# **Practical Device Test Fixtures for 100G KR ... or Not and the Impact on ERL and $P_{\max}/V_f$ (ref: comment 19, 20, 21, 25)**

IEEE 802.3 100 Gb/s, 200 Gb/s, and 400 Gb/s Electrical Interfaces Task Force Interim Meeting  
Geneva, Switzerland

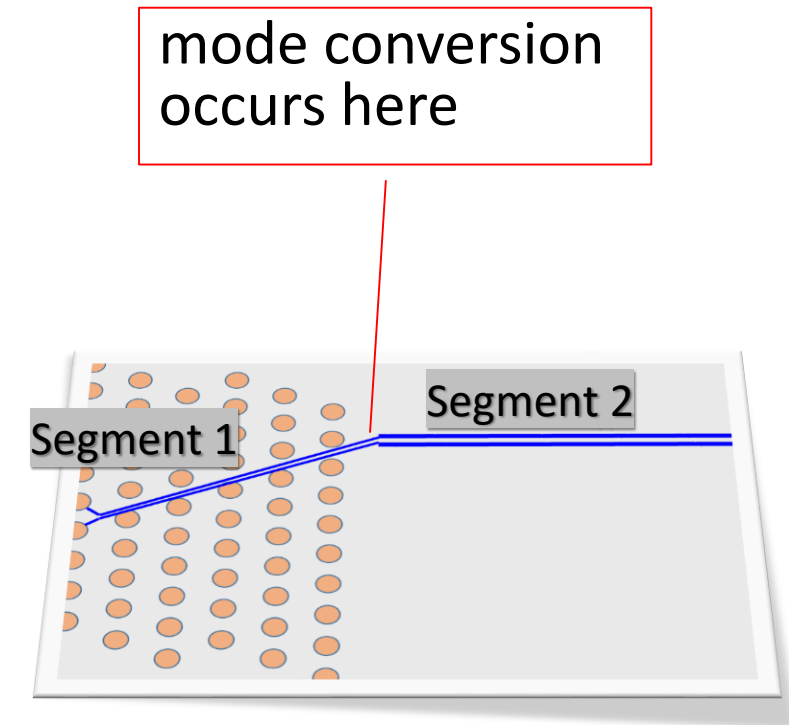
- ❑ The standard allows variability but specs are for the **exact** reference fixture.
- ❑ It's the implementer responsibility to adjust
  - “The bridge doesn't care that the truck height has variability”
- ❑ Question:
  - How much margin does a perfect fixture cost?

# Idea: 1.4 dB (@ 26.56 GHz) Fixture Strawman

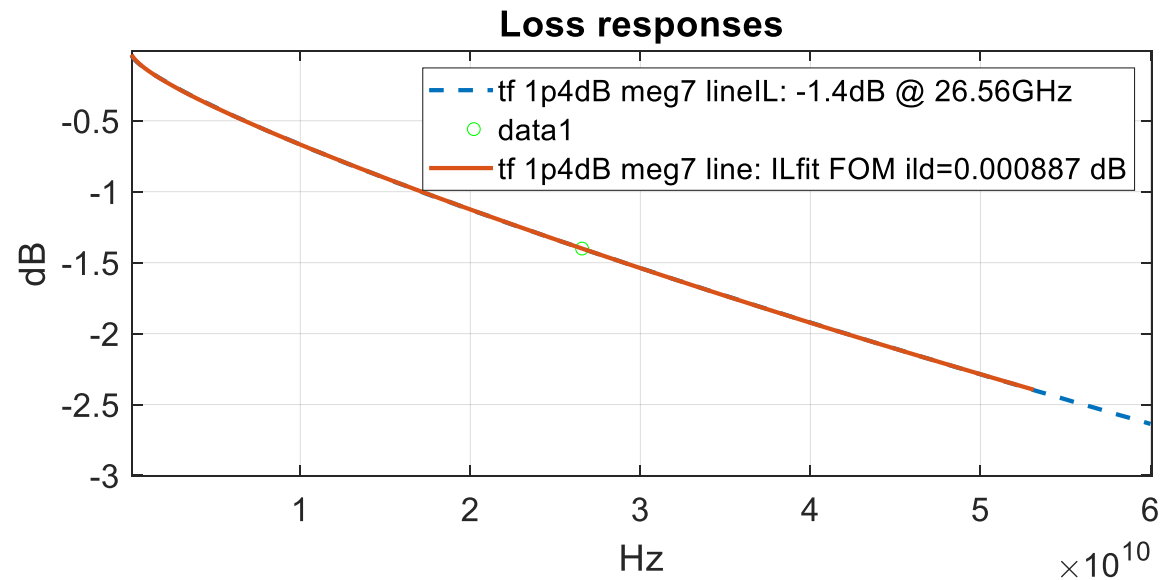
❑ For this experiment replace equation 93-1

- 1.4 dB at 100 ohm (differential) Megtron 7 H-VLP (strawman for reference fixture)
- Dotted blue line is the actual measurement
- Red line is the fit with above coefficients

- $IL_{ref} = 0.0037 + 0.1052\sqrt{f} + 0.0337f$

# Recommended Parameters for Computing ERL, $V_f$ , $P_{\max}/V_f$

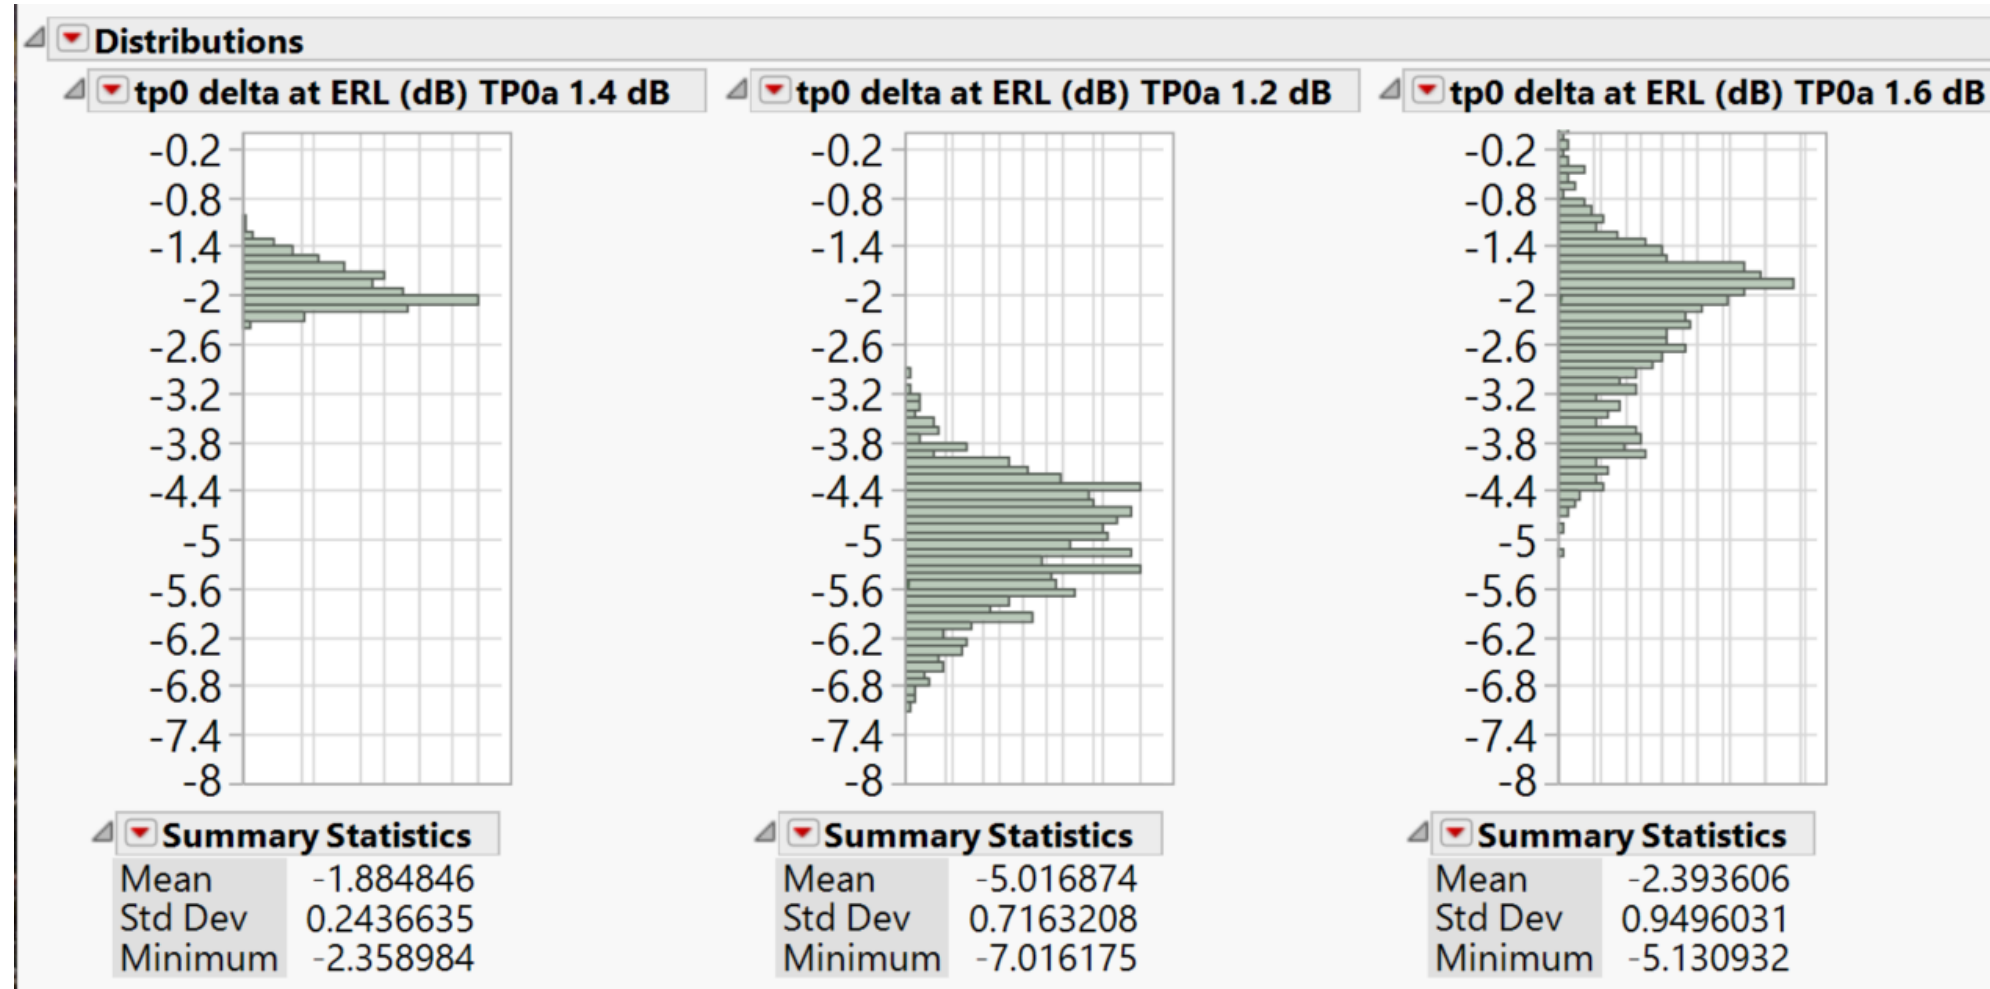
- $N_{bx} = 21$  (comment 22 modified)
  - Seems to be consensus here:  $21 = N_b + N_f * N_g$
- $\beta_x = 2.4$  GHz (comment 21)
- $\rho_x = 0.32$  (comment 21 modified)
  - Seems to be consensus to keep same as .3cd
- $N = 200$

- $N_v = 200$ 
  - In practice when computing from s-parameters and a computed step response this value may need to lower because of some data may not have sufficient low frequency data.
  - Produces a  $V_f$  more like a real steady state voltage
- $k = -3$  to  $1$
- $D_p = 4$

# ERL<sub>min</sub> Recommendation

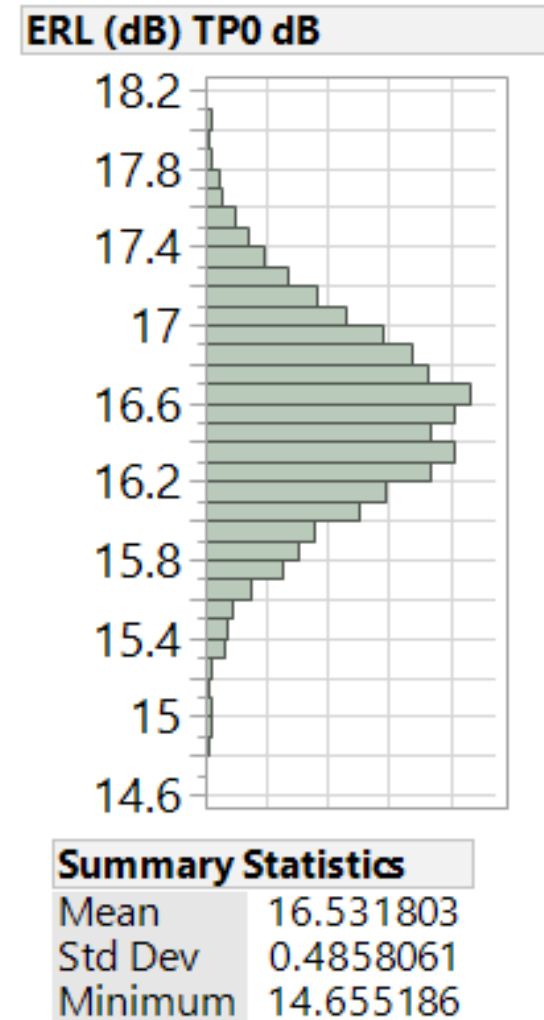
- ❑ For 50000 cases manufacturing cases the minimum ERL is 14.65 dB
- ❑ Subtract 0.2 dB for fit uncertainty
- ❑ Recommend ERL<sub>min</sub> = 14.45 dB
  - Measured at tp0 (and TP5)

# $P_{\max}/V_f$ Recommendation

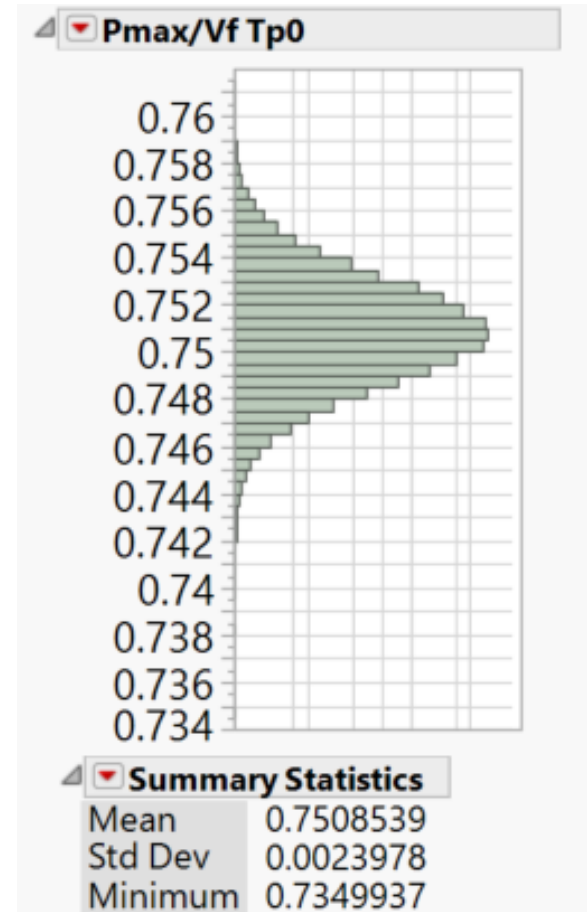
- ❑ For 50000 cases manufacturing cases the minimum  $V_{\text{peak}}/V_f$  is 0.734
- ❑ Subtract 0.002 dB for fit uncertainty
- ❑ Recommend  $P_{\max}/V_f \text{ min} = 0.73$ 
  - Measured at TP0 (and TP5)
